**REVIEW OF DRAFT  
HOT SPOT FEASIBILITY STUDY, NEW BEDFORD HARBOR,  
MAY 1989, BY EBASCO SERVICES INCORPORATED  
EPA WORK ASSIGNMENT NO. 04-1L43  
EPA CONTRACT NO. 68-01-7250**

Review by:

Dr. Malcolm L. Spaulding  
Applied Science Associates, Inc.  
70 Dean Knauss Drive  
Narragansett, RI 02882

July 28, 1989

Figure 1 Cumulative remediated volume (cy) and cumulative PCB mass reduction (%) versus sediment PCB target levels (ppm) for New Bedford Harbor sediments.

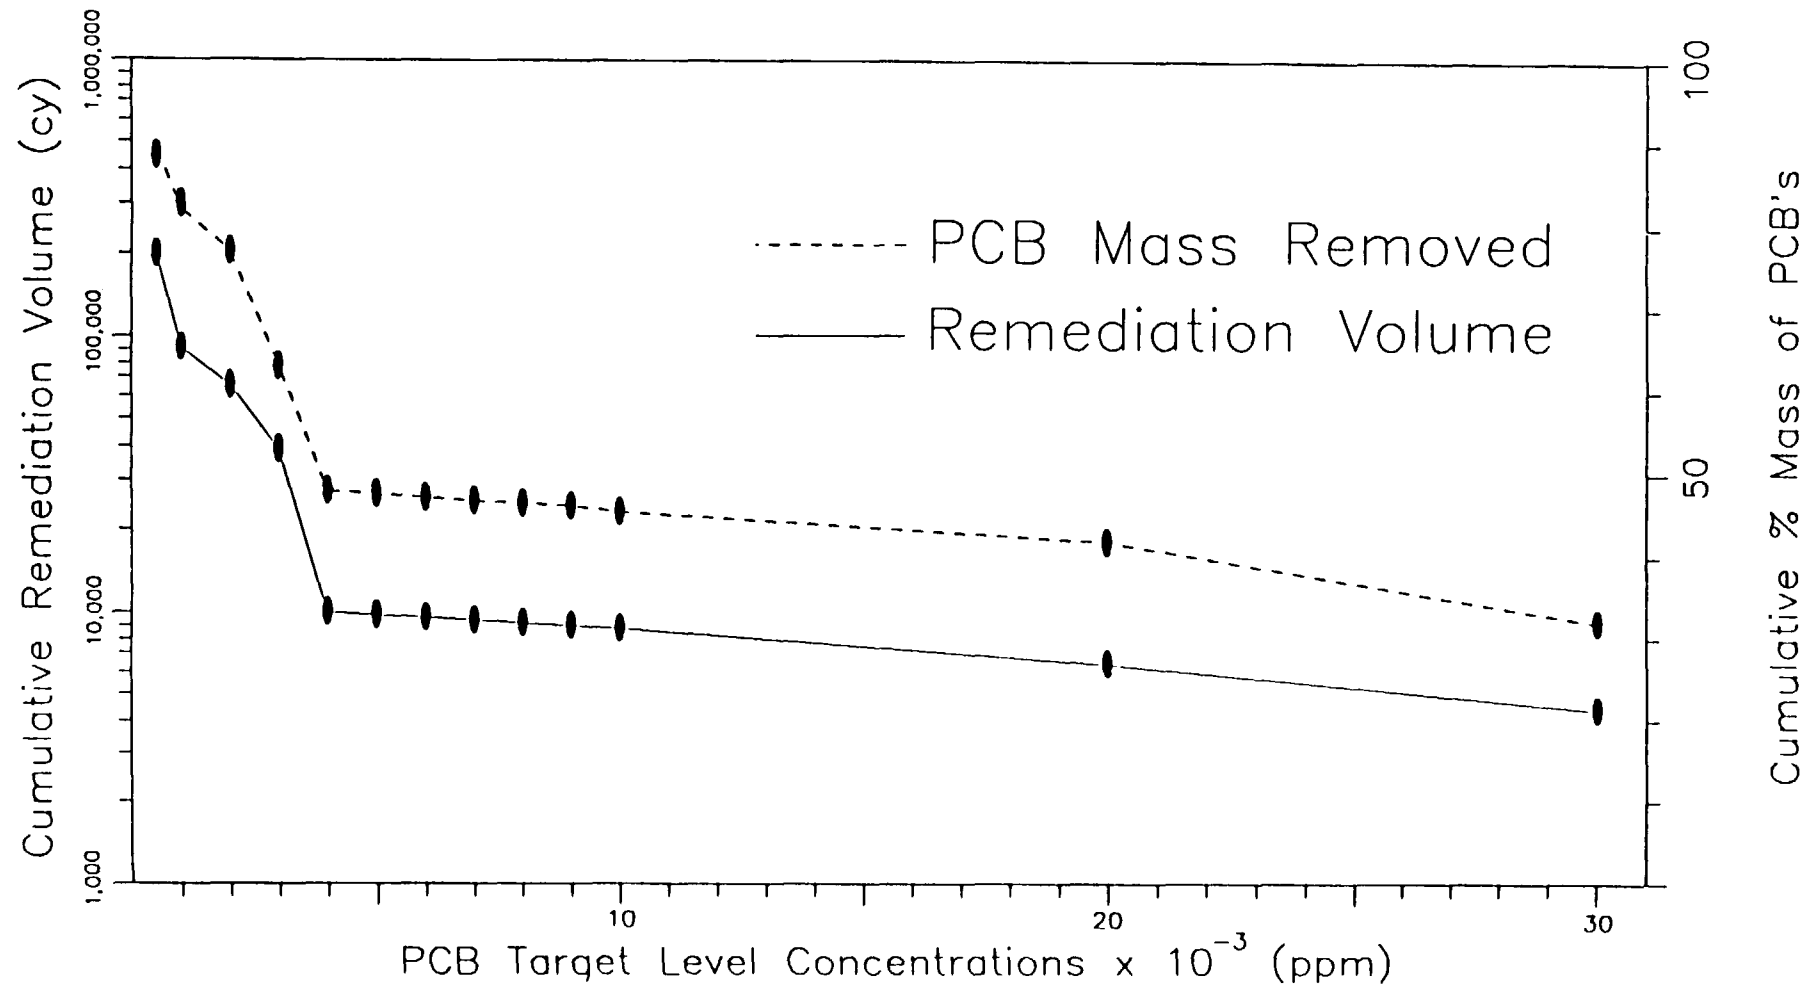
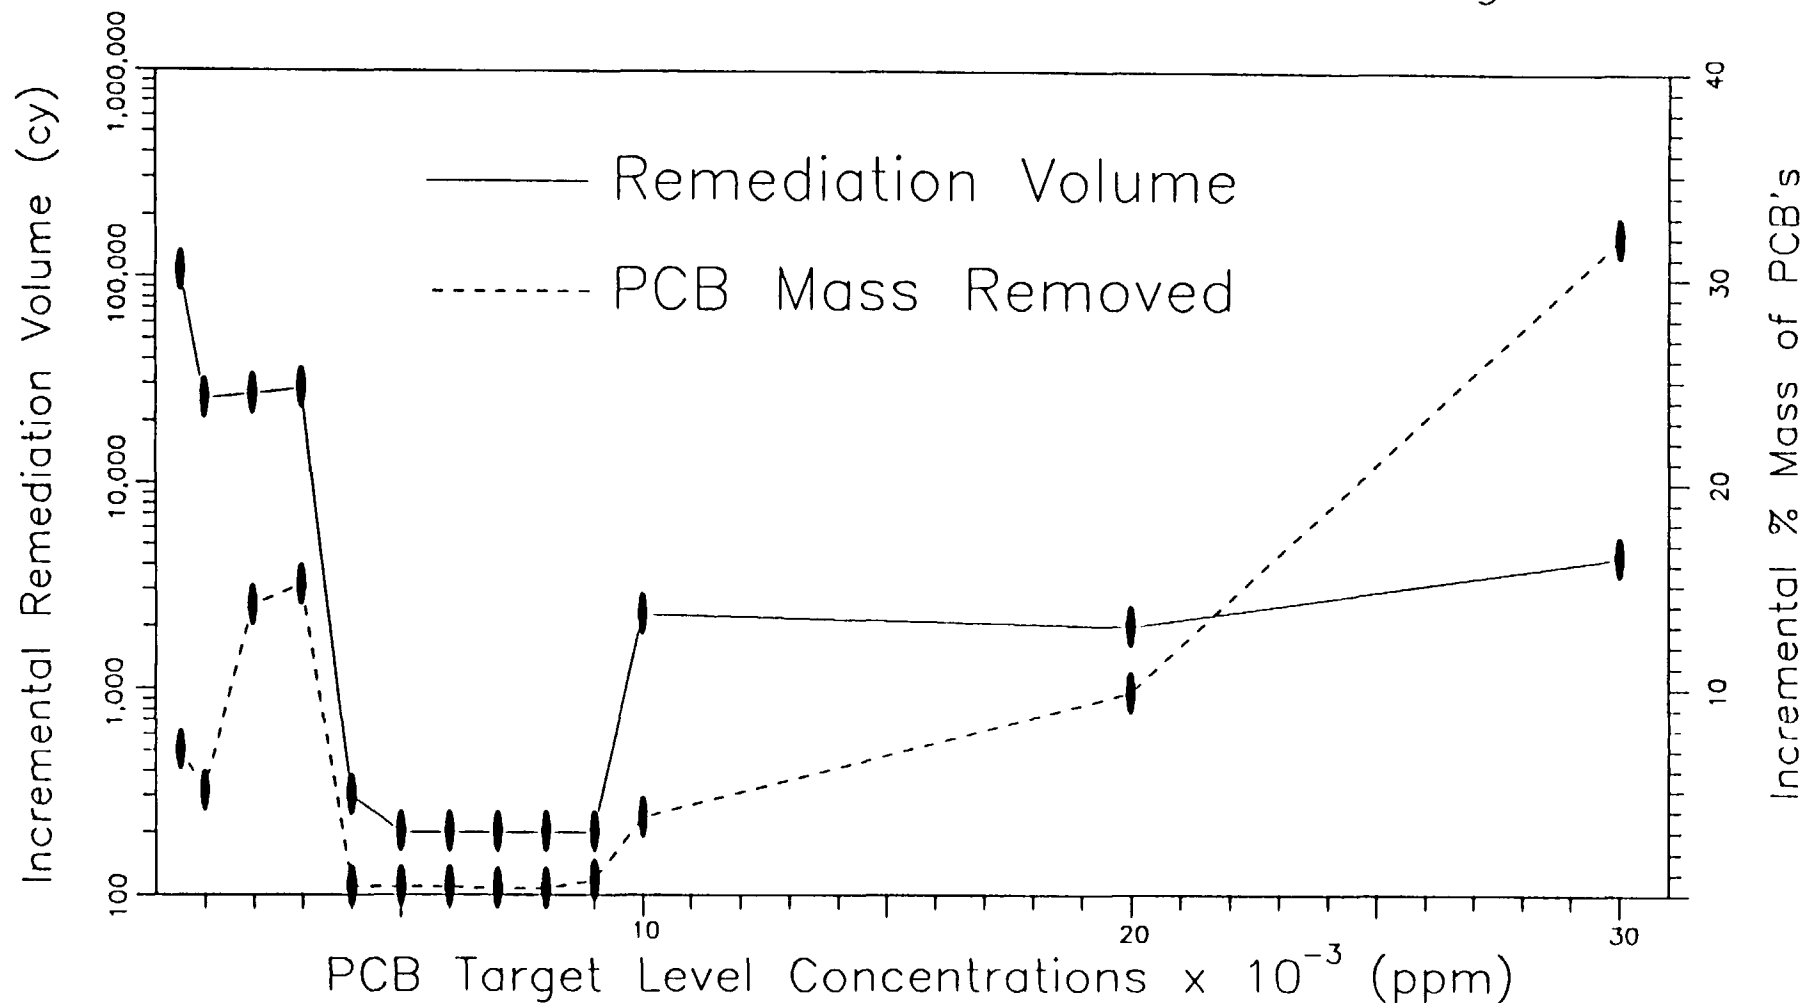
Treating sediments at the 30,000 ppm level requires a remediation volume of 4,400 cy and reduces PCB mass by 32% (Table 1, Figure 1). Lowering the target level to 20,000 ppm increases the volume to be treated by 2,000 cy and removes 41.8% of the PCB mass, an increase of 9.8% over the 30,000 ppm target level (Figure 2). If the target level is further lowered to 10,000 ppm an additional 2,300 cy must be treated but the benefit is only a 3.7% reduction in PCB mass.

It is interesting to note that exactly 200 cy must be treated to achieve each 1000 ppm increment reduction in the target level for target levels between 10,000 and 5000 ppm. This is clearly shown in Figure 2. At first glance one would suspect that the data in this range were artificially generated.

Figure 3 Ratio of incremental PCB mass reduction (%) to remediated volume (cy) versus sediment PCB target levels (ppm) for New Bedford Harbor sediments.

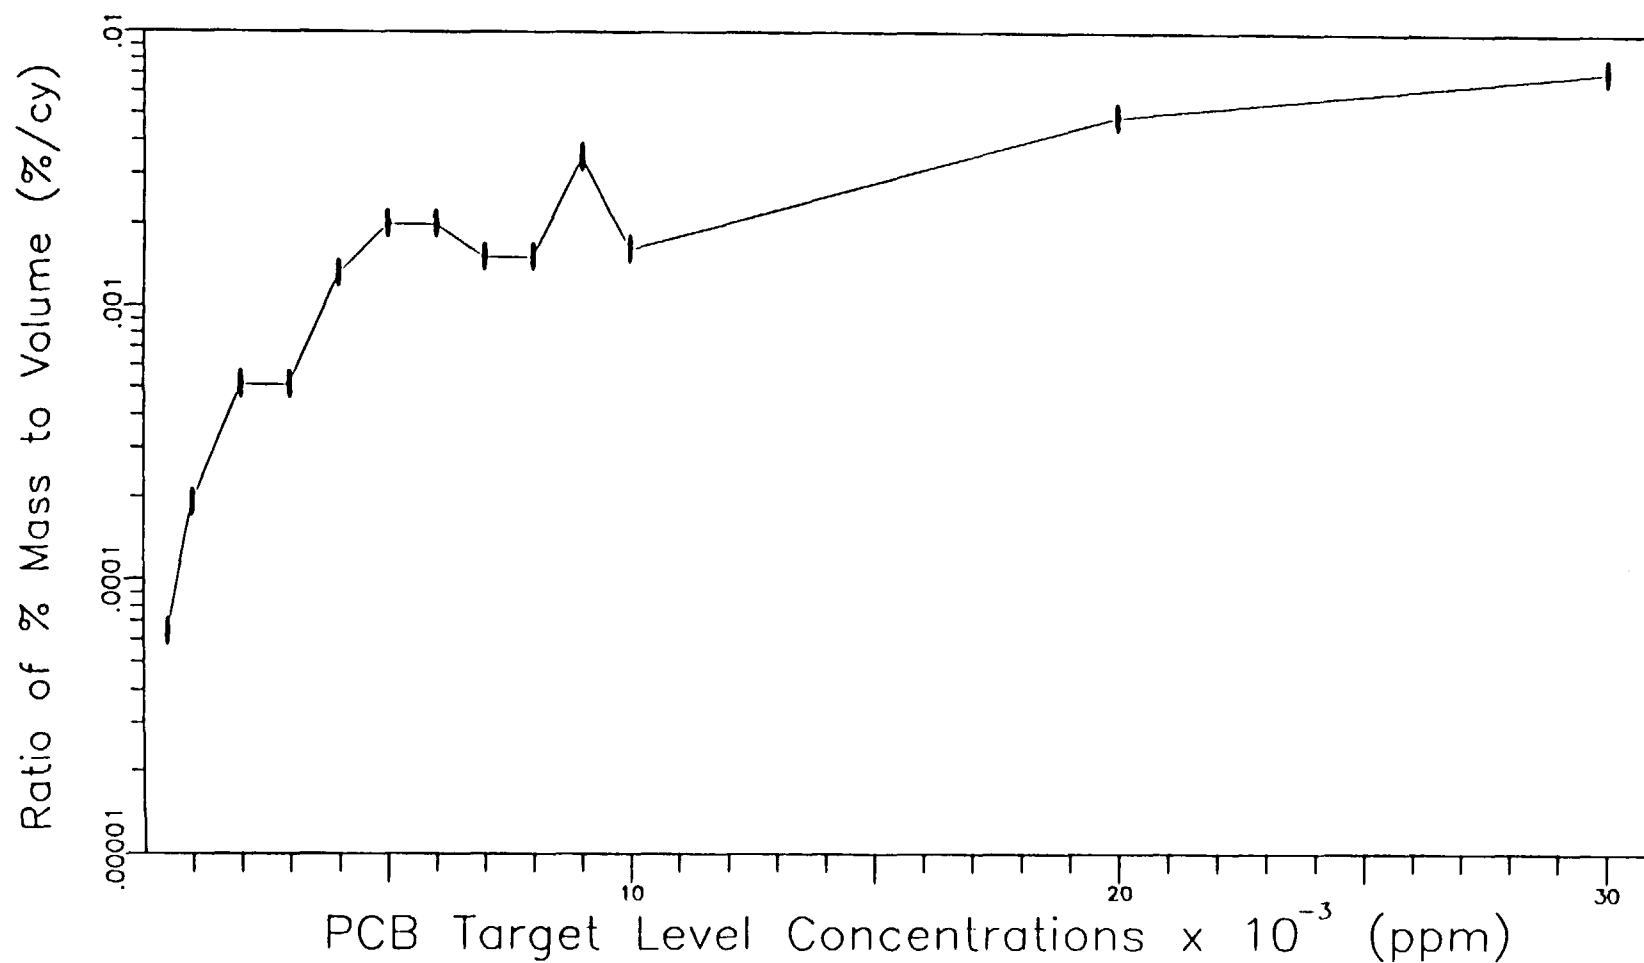
On a PCB mass removed divided by the volume required to be treated basis the incremental reduction from the 30,000 to 20,000 ppm target level compared to the 20,000 ppm to 10,000 ppm is reduced by more than one half (Figure 3). The incremental benefit in treating at increasing lower target levels continues to decline.

In general, as the target level declines, the volume of sediments which must be remediated for each % of PCB mass removed continues to increase. The exception is at a target level of 9000 ppm which shows a local maximum in the ratio of % PCB mass removed to volume remediated. This local maximum could readily be caused by uncertainties in contouring of the sediment PCB data.

Figure 3 suggests that a target level of 9000 or 10,000 ppm is more appropriate than the proposed 4,000 ppm level.

Figure 4 Total PCB water column concentrations (ug/l) versus longitudinal distance (km) for Battelle's data (1987). Summary of cruises 1, 2, and 3.

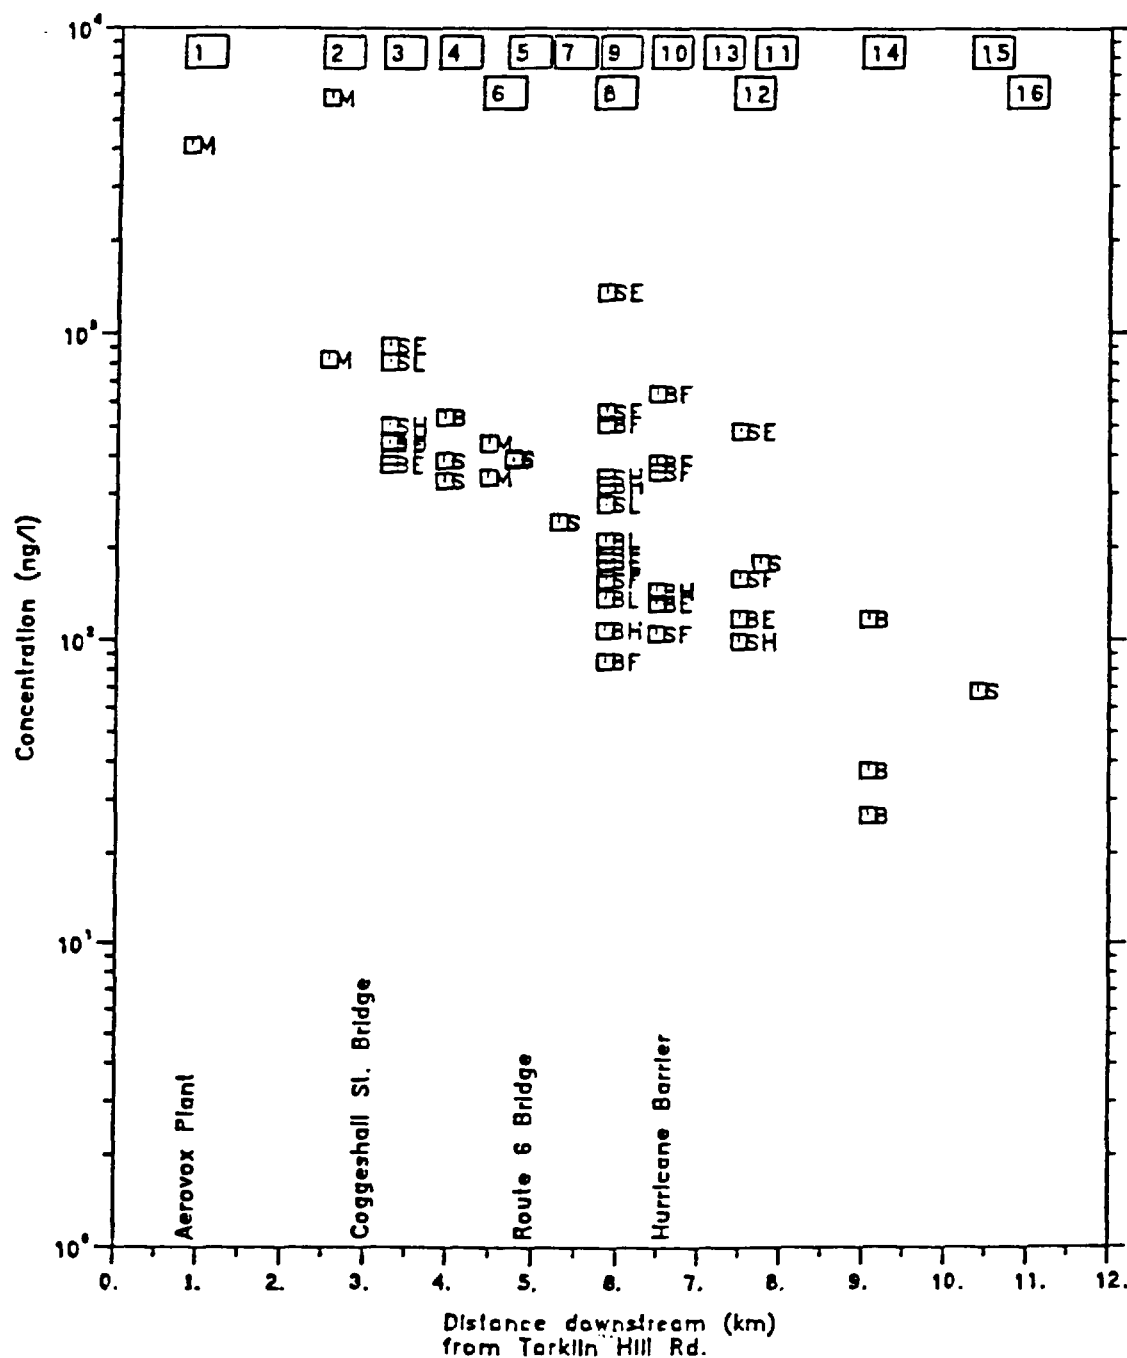
Battelle (1987) collected data at only two stations in the upper estuary; one station near Aerovox and the second just upstream of the Coggeshall Street Bridge. Figure 4 shows a summary of the total PCB concentration data for these two stations as well as the remaining stations in the survey. All three cruises are included in this data set.

Contrary to what is reported the mean concentration level in the vicinity of the hot spot is 4,000 ng/l not the 13,754 ng/l reported. The lower harbor and bay data, however, are consistent with Battelle's data.
